St Alphege

Faculty Application

PROJECT TURNAROUND:
Further addendum to the DESIGN NARRATIVE

November 2025

GROUND FLOOR PLAN - UPDATED PROPOSALS

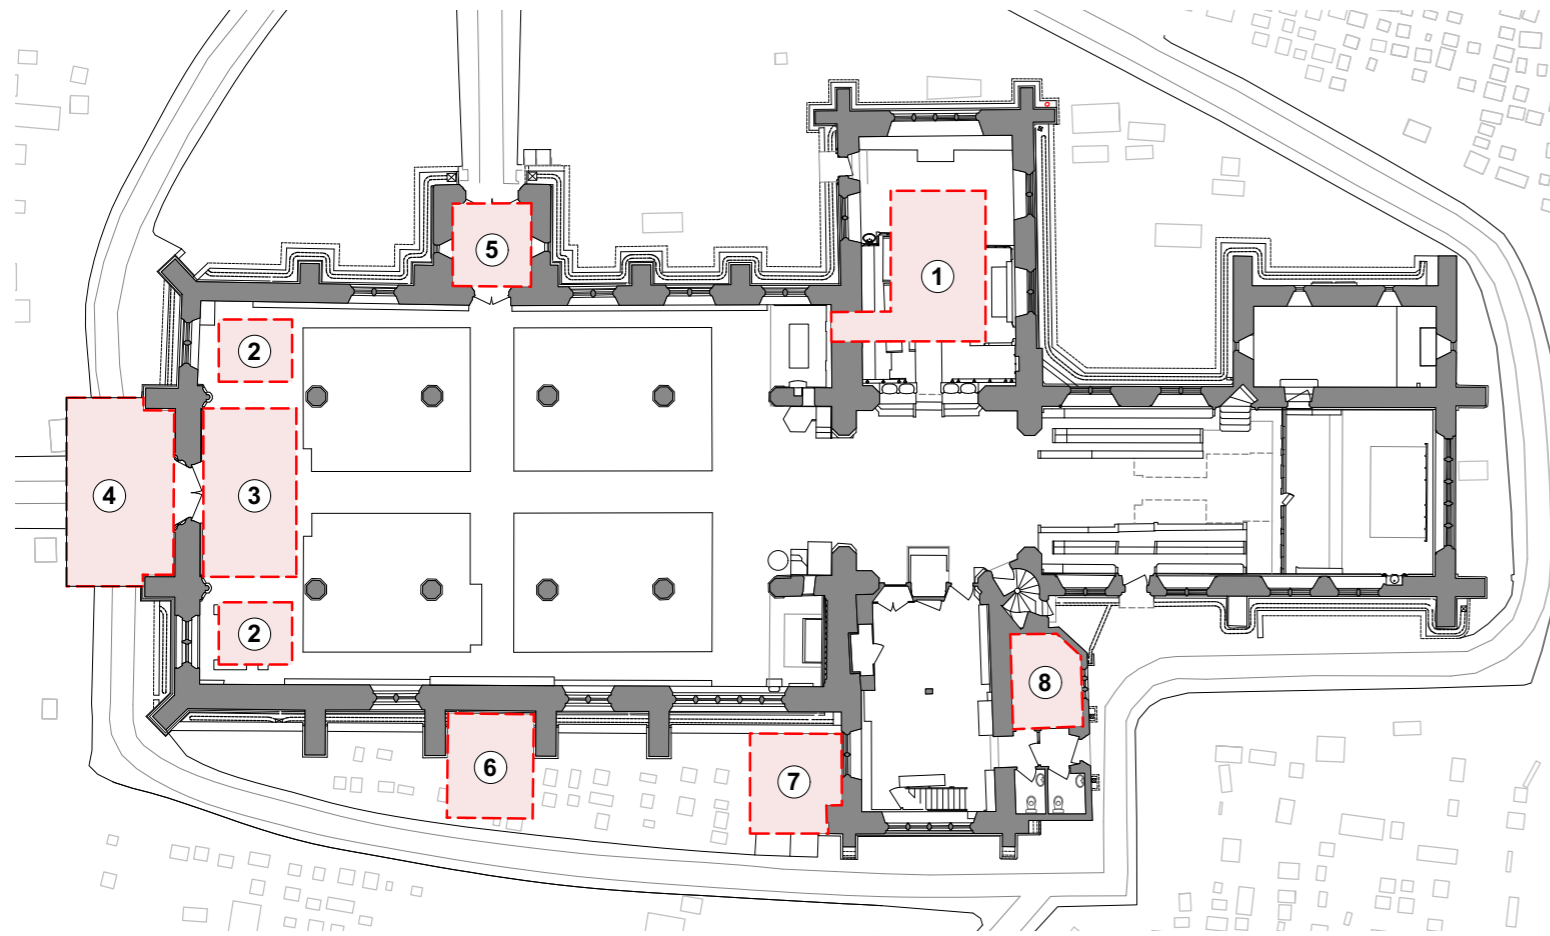
The key amendment to the proposals for St Alphege is the relocation of the new toilet provision, taking on board the objections raised to constructing a new external narthex at the west end of the building.

The new location now proposed engenders less significant amendments to other parts of the original proposals: for instance the relocation of chair storage and the children's area. Proposals for the west entrance now focus on a new glazed door, and works to the landscape beyond will be less extensive.

2.0 WEST ENTRANCE PROPOSALS

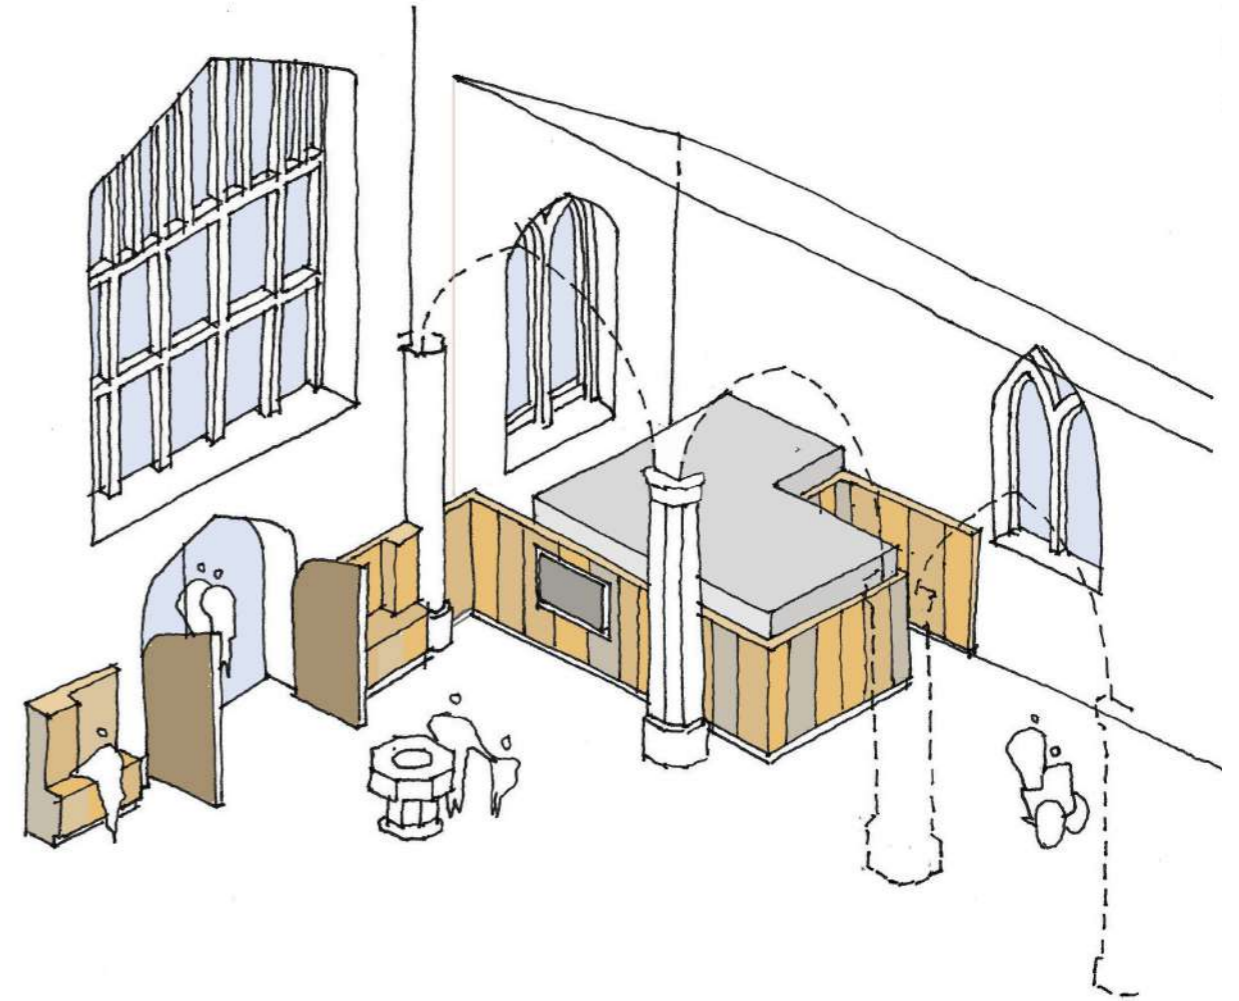
The new proposal from the PCC is to provide toilet facilities within a timber 'pod' at the north-west corner of the church (location 2 on the above plan).

The volume will contain one male, one female and one accessible toilet, each arranged as a self-contained cubicle with its own hand basin. To the west, the enclosure serve as storage space for stacks of chairs and folding tables. On the south face of the new volume a recessed space is proposed to house a digital screen allowing information to be displayed to visitors in a prominent location. The higher ceiling heights required over the cubicles will be expressed as a set-back volume above the timber-clad walls, which will sit below the western window sills,

The walls of the toilet cubicles will be constructed from timber studwork and lined internally with moisture-resistant plasterboard, with acoustic insulation incorporated within the build-up to reduce noise transfer. Ventilation will be provided through a flexible duct linking the cubicles at high level, which will require a small penetration through the north wall.

PROPOSED FLOOR FINISHES (see drawing 0211 in Drawing Pack)

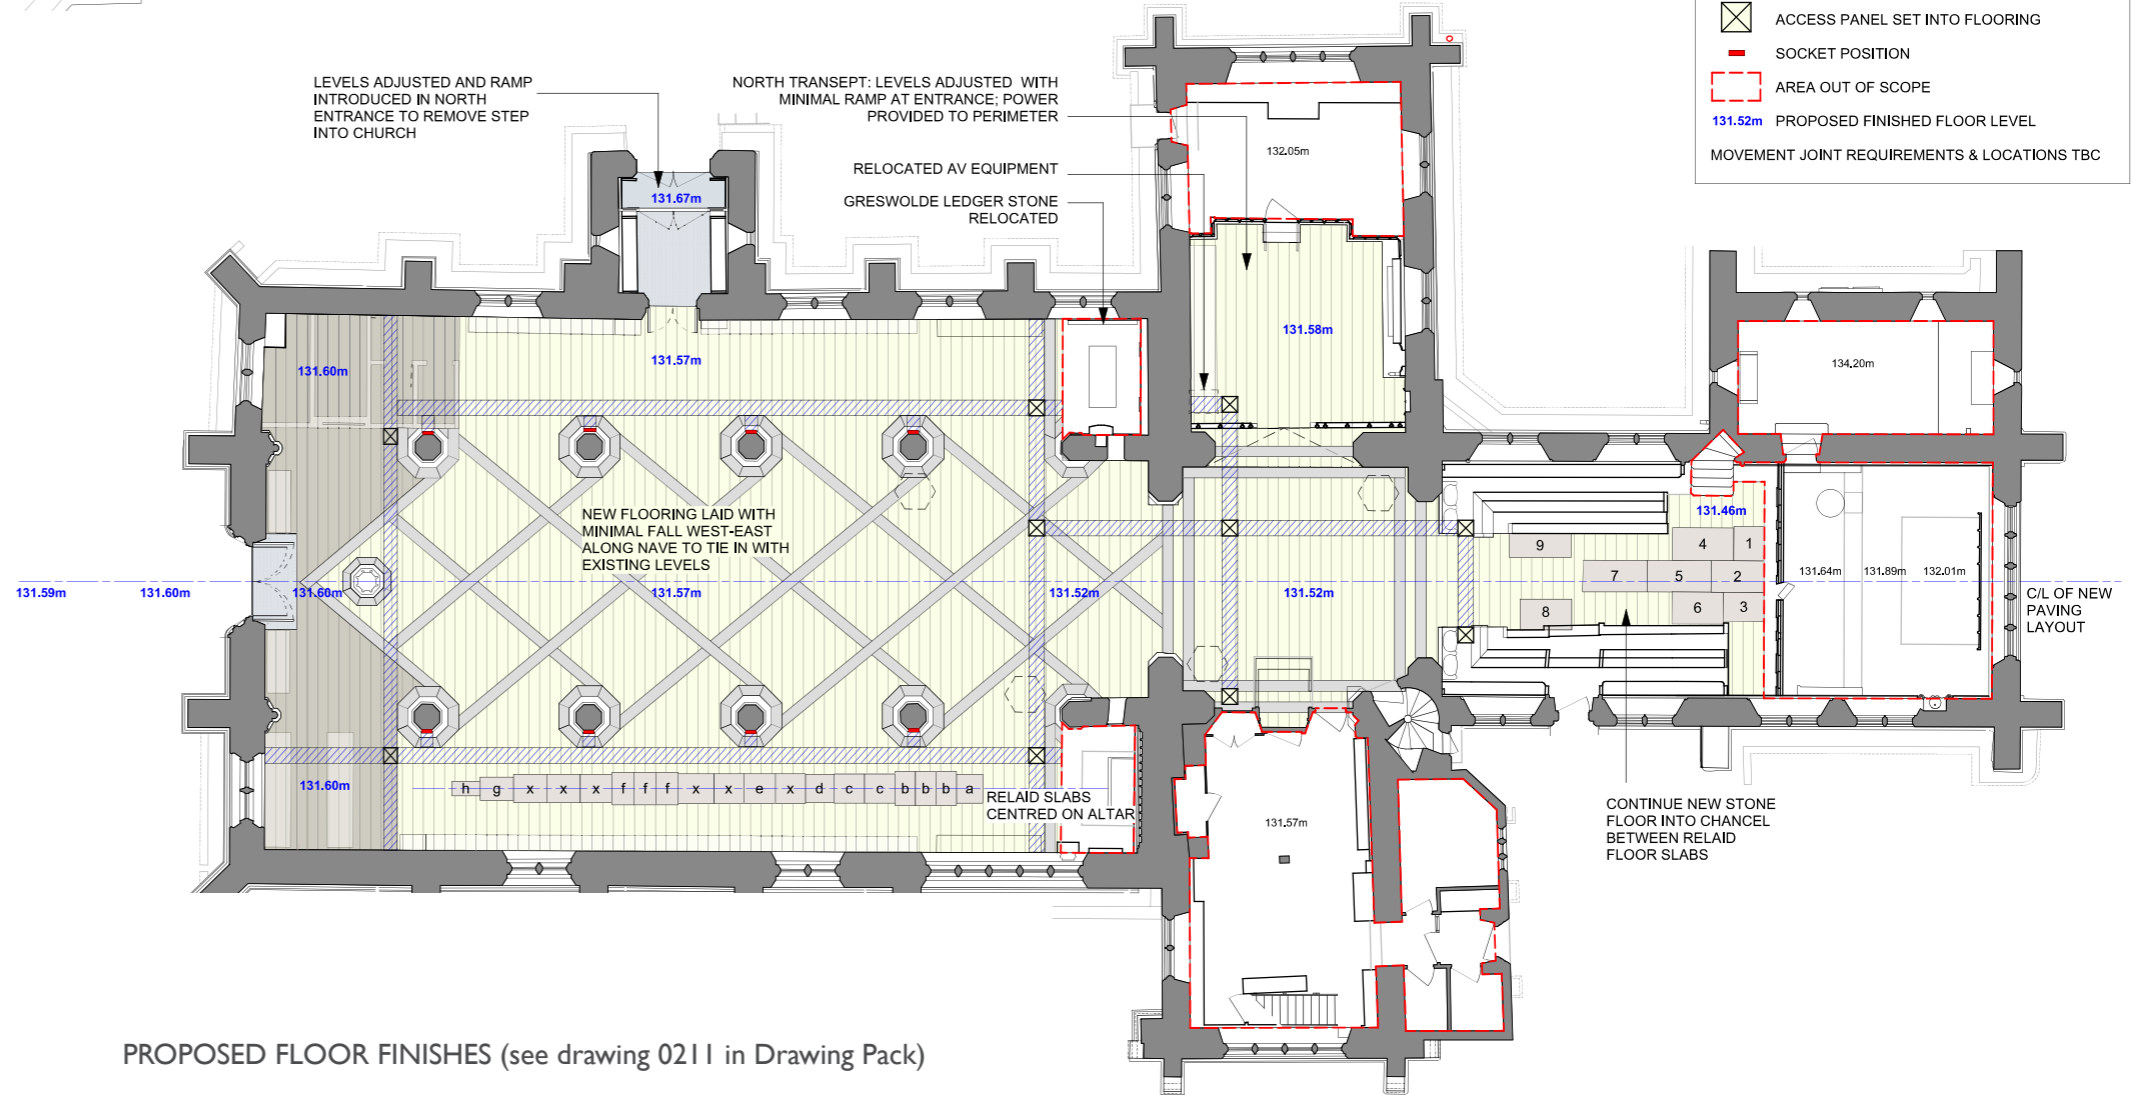
The proposed floor finishes drawing (0211) indicates that those ledger stones in the chancel will be carefully lifted and relaid in the same locations, with the new stone running around them. In the south aisle, the ledger stones have clearly been moved previously, with several split into multiple pieces. The proposal here is to relay these stones along the south aisle with the broken sections reunited, centred on the Chapel of St Anthony, thus improving the legibility of the monuments in situ. No ledger stones will be moved outside.

The current proposals include retaining a mixture of materials in the more historic parts of the floors (chancel and south aisle); however where the pew islands and carpets are being replaced, the priority is a unified surface for optimum flexibility and access.

Within the design of the floor we have integrated a pattern to break up the larger areas using contrasting stone finishes and textures to ensure a variation in finish is maintained.
